ADDENDUM NO. 01

Amendments to RFP/EPC Bidding Document for Engineering, Procurement and Construction (EPC) of Attabad Lake Hydropower Project (54 MW) Package-III: Electro-Mechanical Works

This Addendum No. 01 to RFP/EPC Bidding Document containing the following amendments to the EPC Bidding Document for Engineering, Procurement and Construction (EPC) of Attabad Lake Hydropower Project (54 MW) Package-III: Electro-Mechanical Works is issued pursuant to ITP 8.1 of Volume-I of RFP/EPC Bidding Document.

LEGEND :-

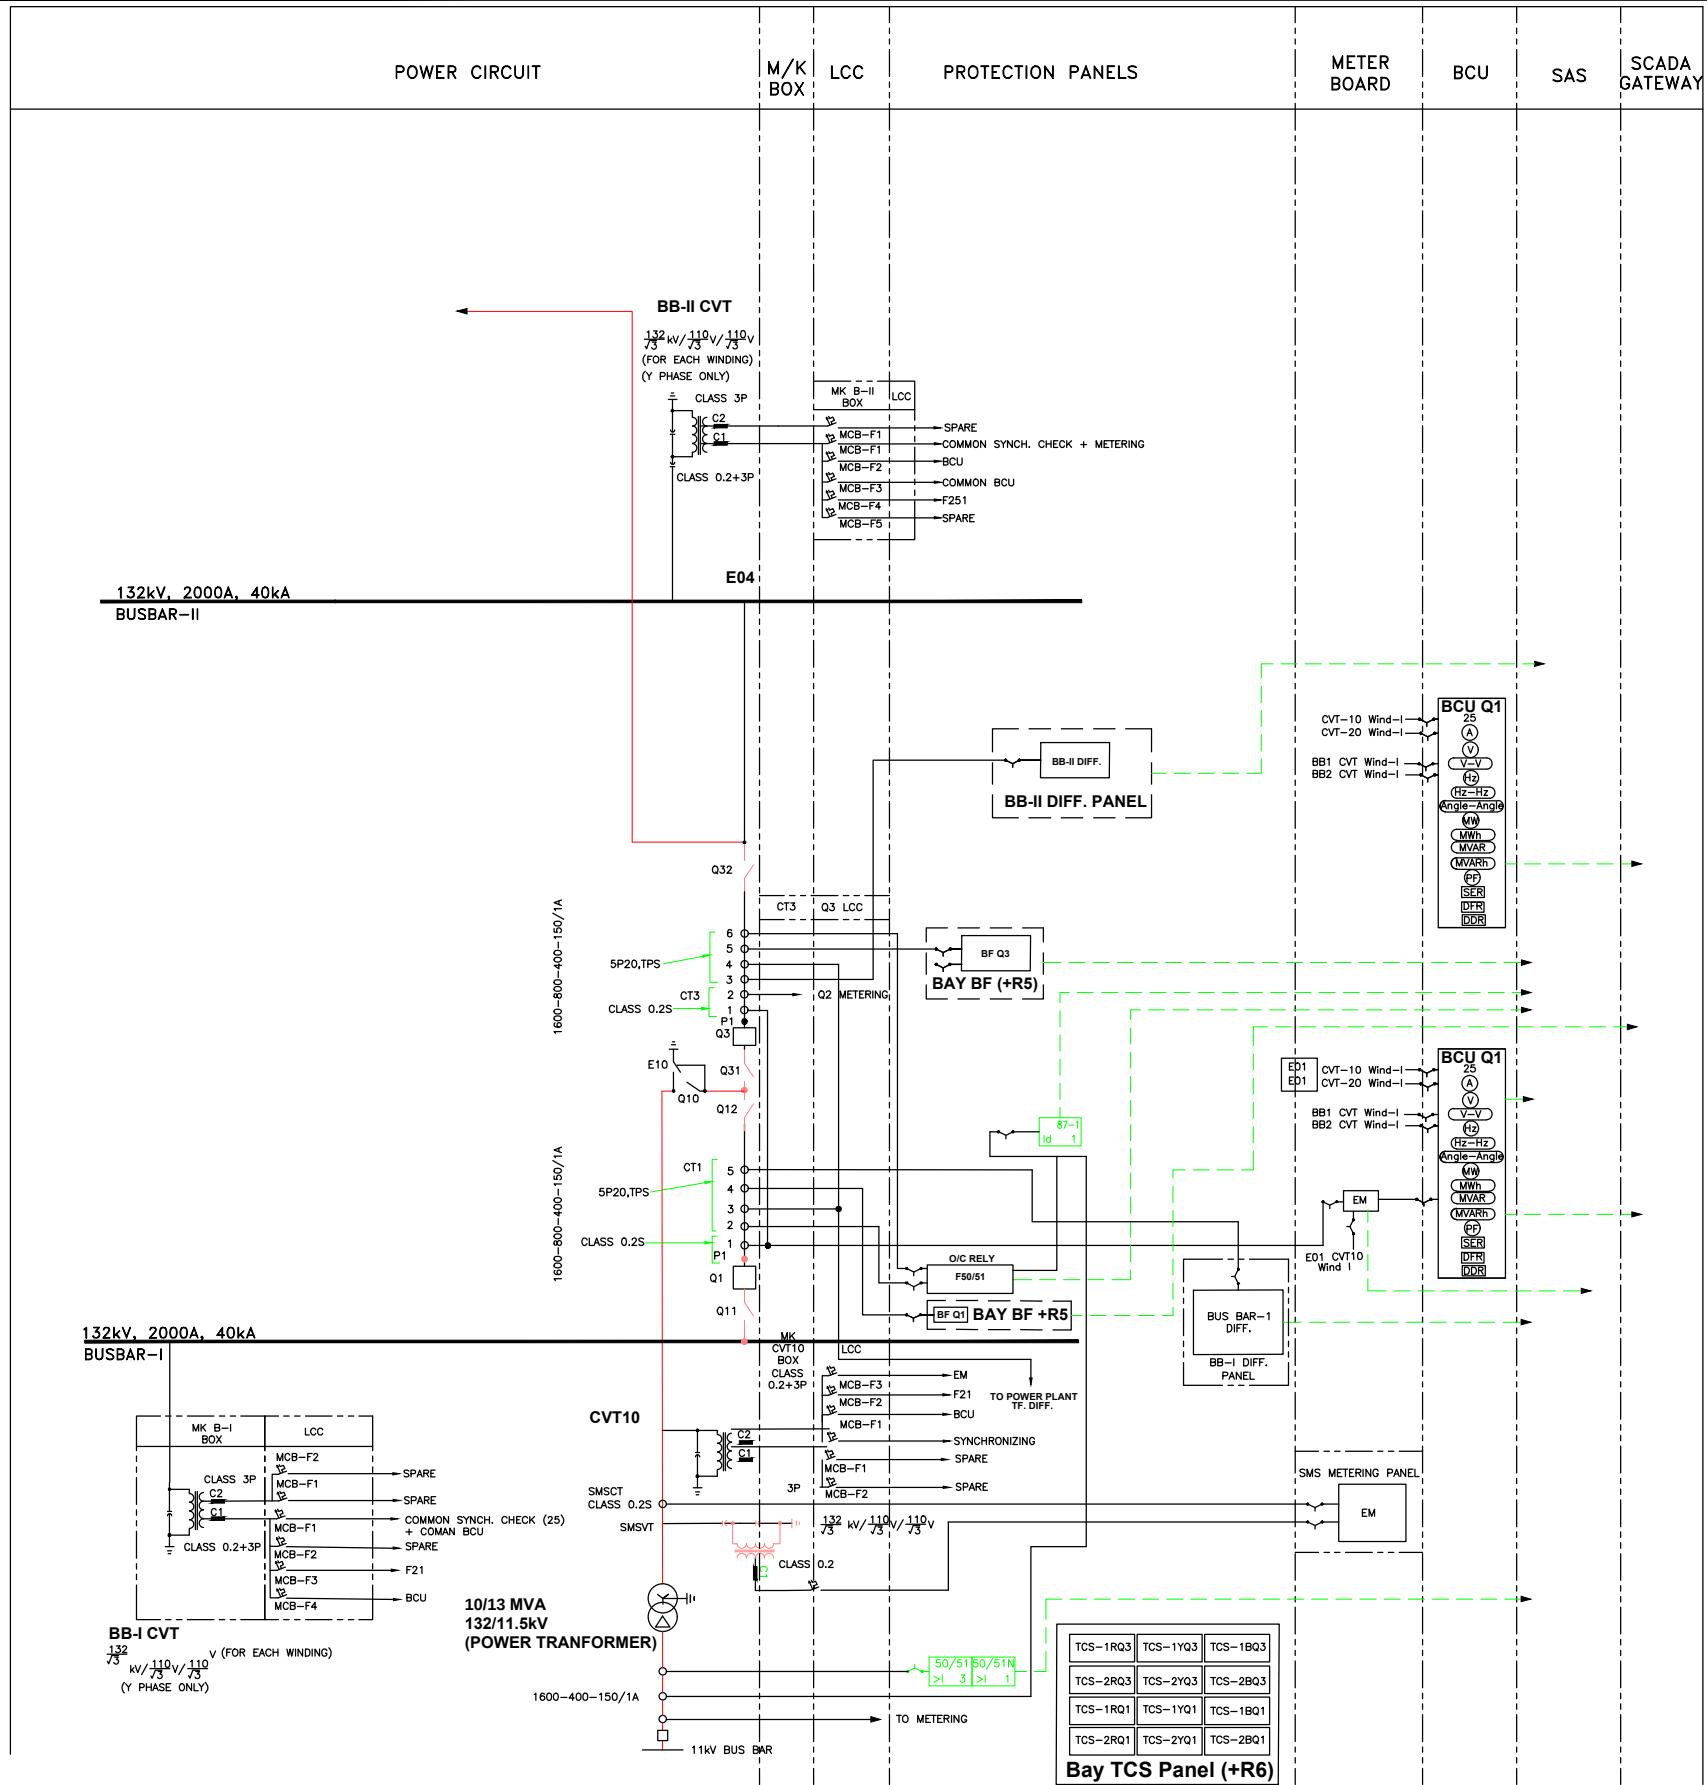
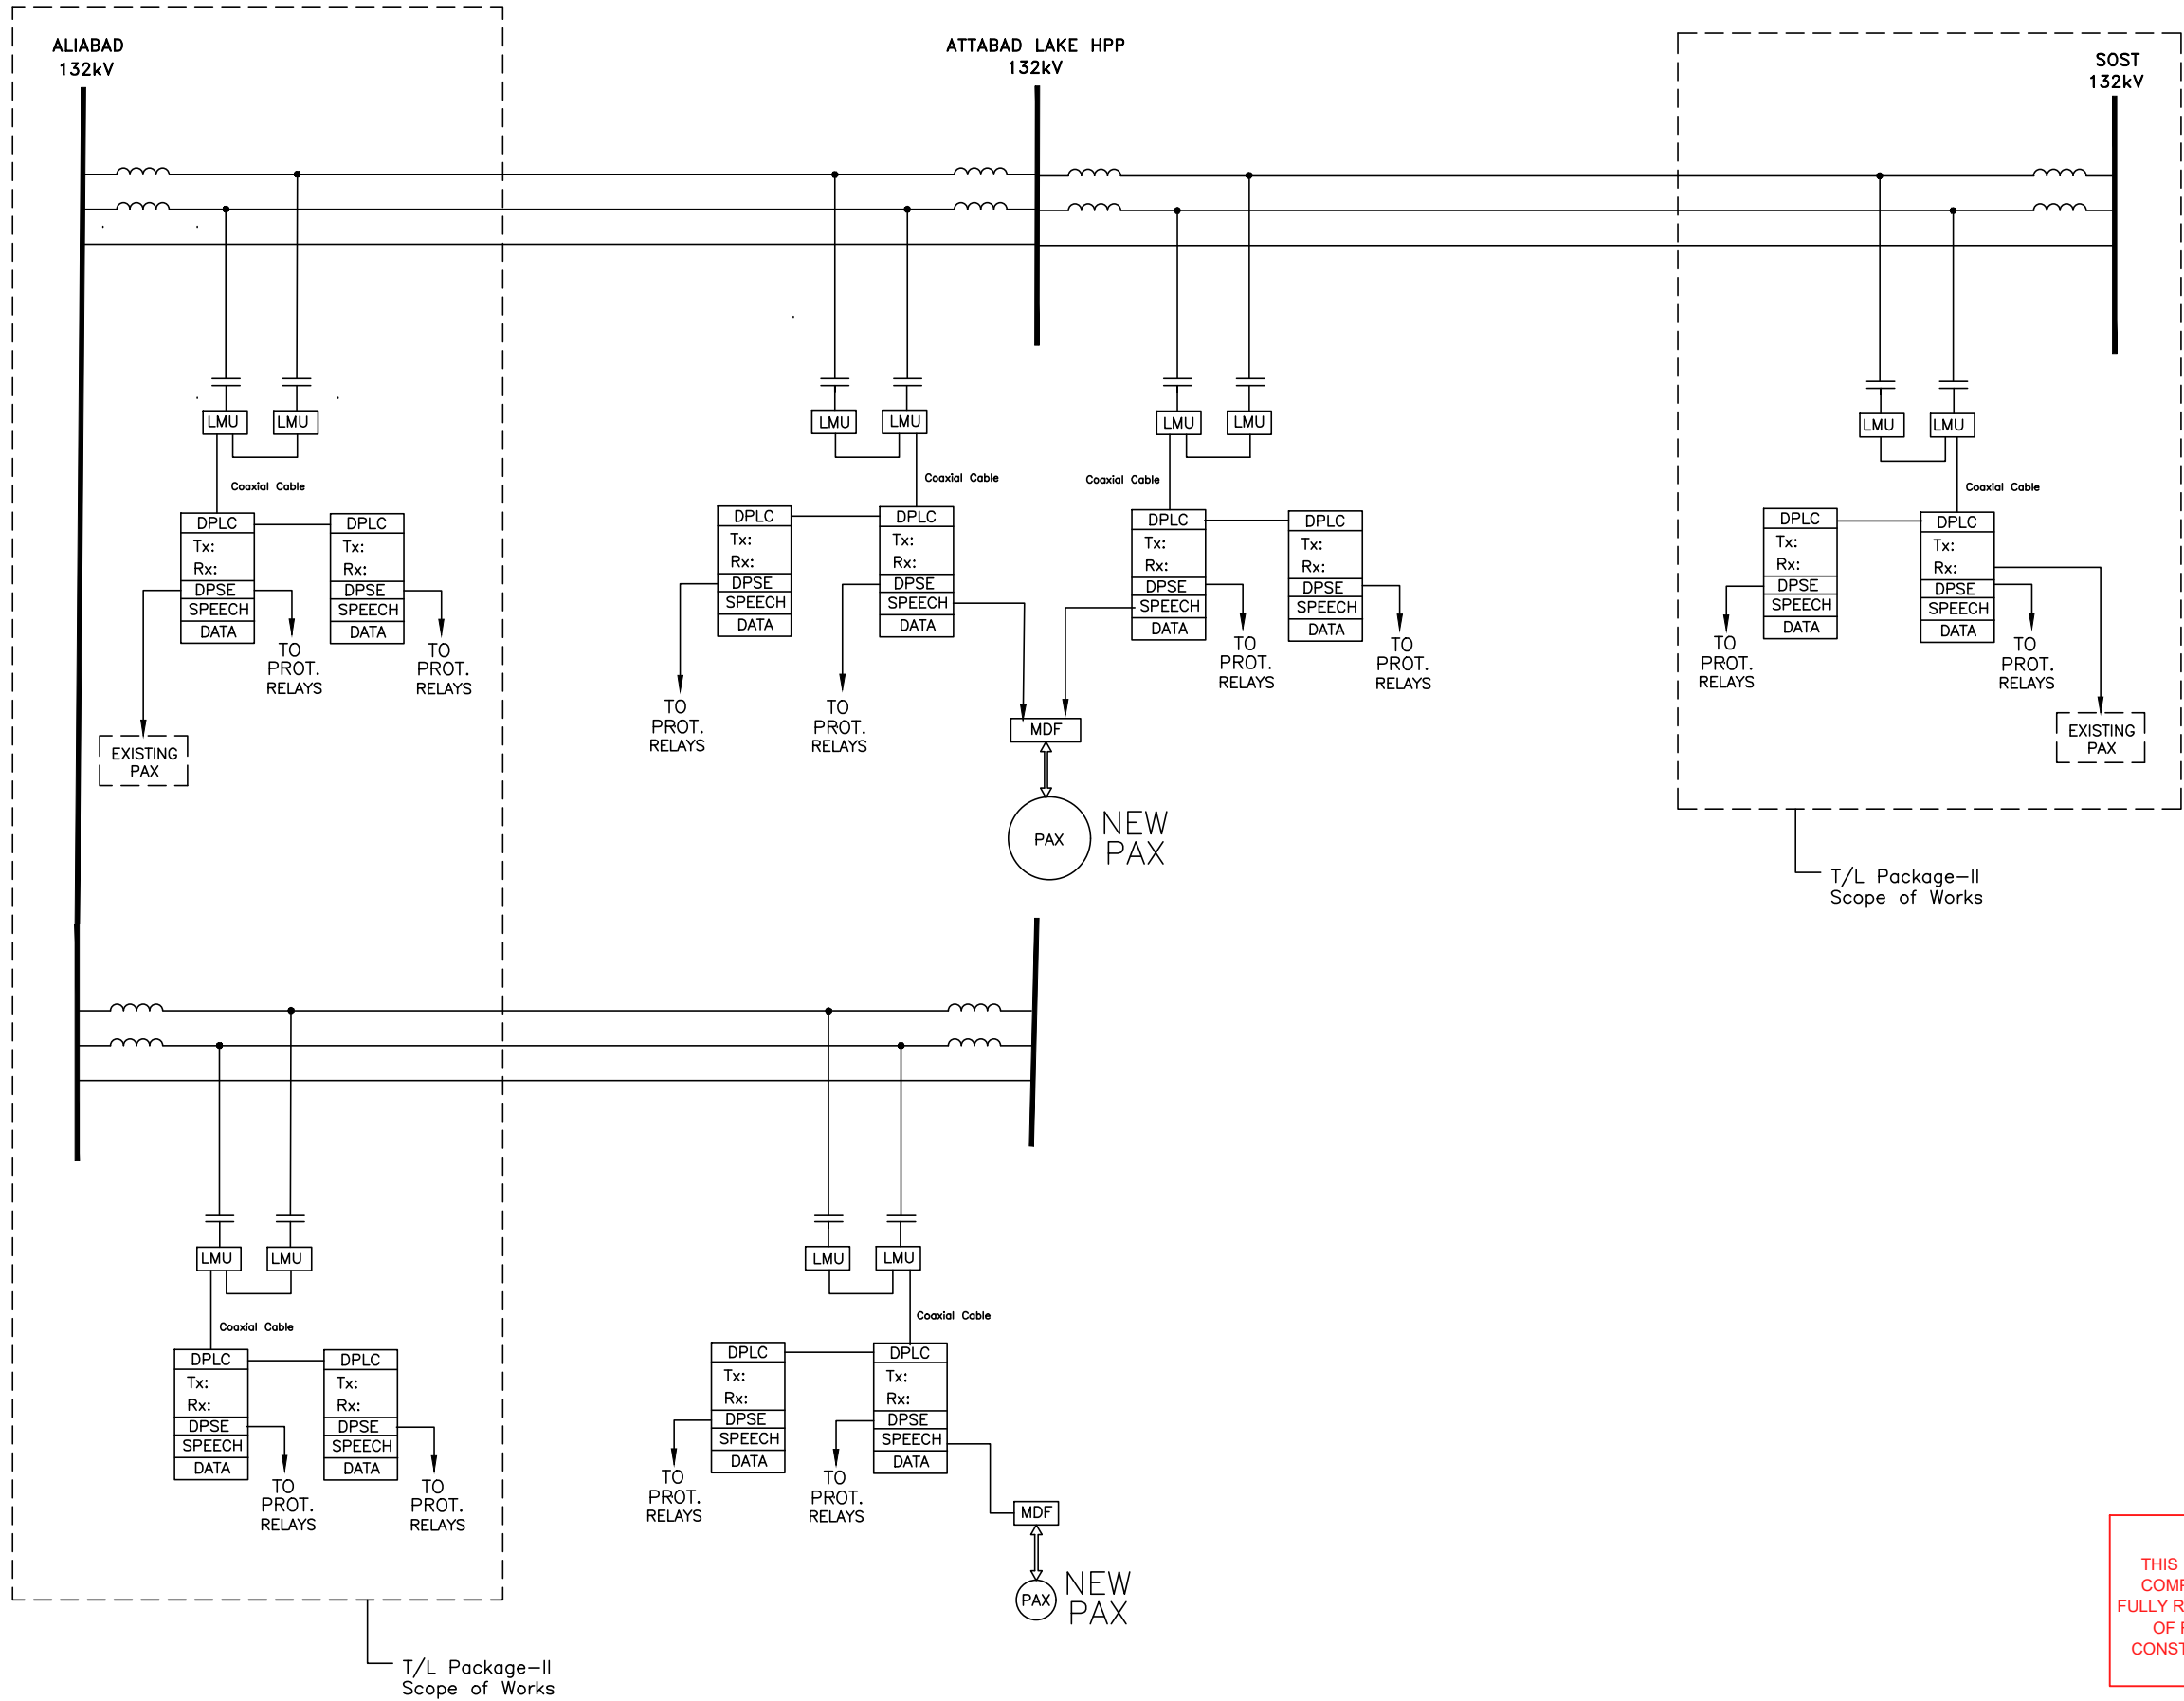
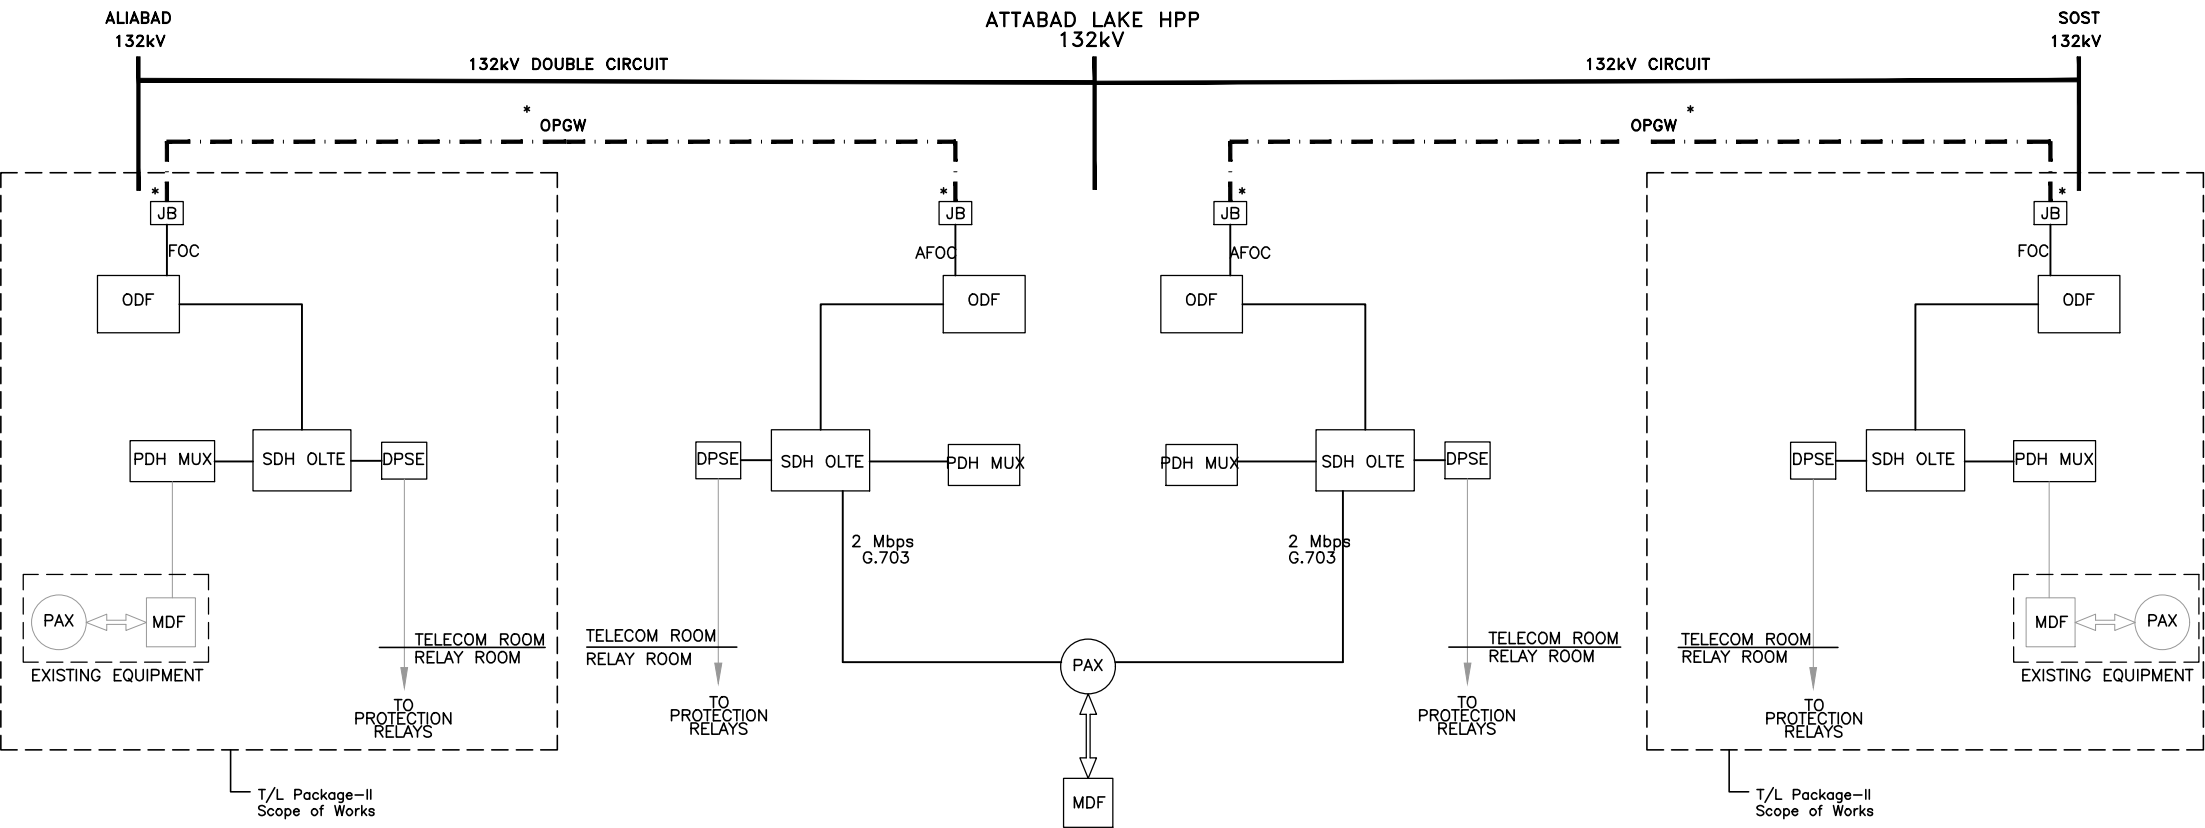
The above-mentioned Conceptual Drawings shall be substituted after deleting in their entirety of 132 kV Remote End Line Bays Conceptual Drawings in accordance with the Original Scope and shall be attached as **Annexure J**.
